**St. Tammany Parish Communications District 9-1-1 Dispatch Center**

ADDENDUM NO. 2

BID NO.: NF-2016-06-16
New 9-1-1 Communications Facility

Date: 28 July 2016

Addendum
 CSK 01
 AD 02

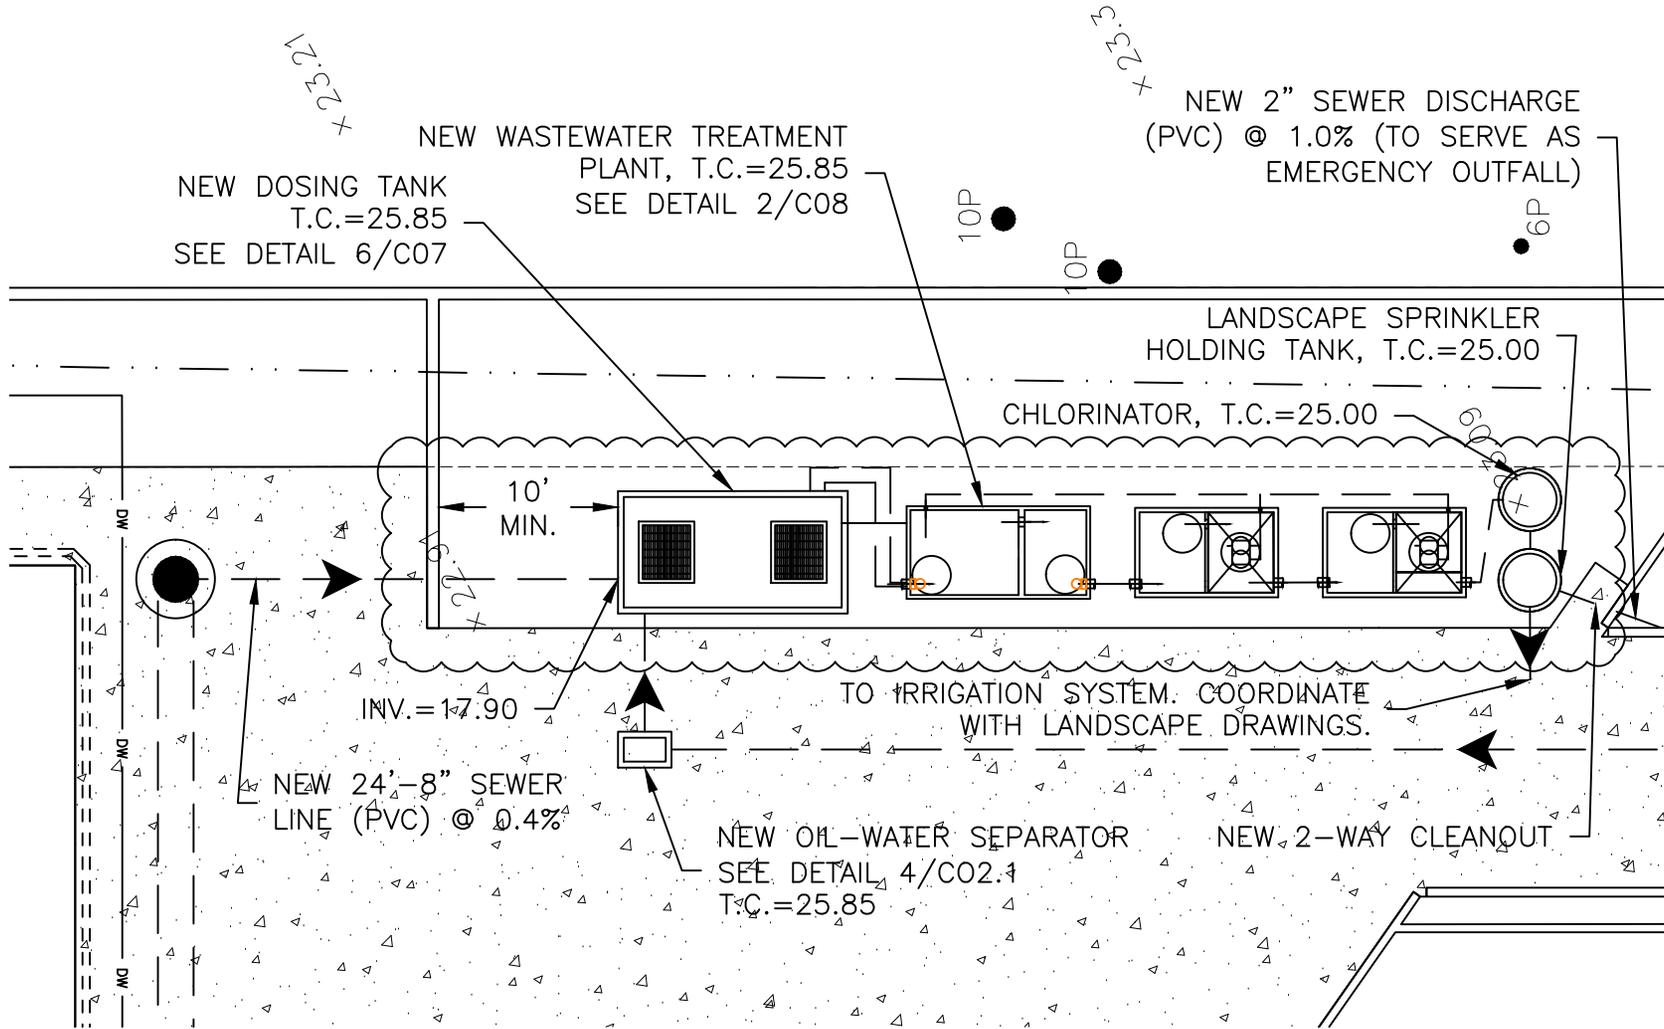
- 2.2 See attached Civil Sketch CSK 01 with layout revision to the Wastewater Treatment Plant.
- 2.3 Sand in the BR Level 4 wall is not specific to product source but must meet ASTM C144 (Reference Detail 01/751). The fine aggregates must fully fill the wall cavity. The distribution of the fine aggregates within the wall cavity must be free from voids.

DOSING TANK NOTES

1. CONTRACTOR SHALL PROVIDE SOLID ALUMINUM ACCESS HATCH (HS-20 LOADING) FOR DOSING TANK.
2. CONTRACTOR SHALL PROVIDE A 3" VENT (J-PIPE) WITH INSECT SCREEN.
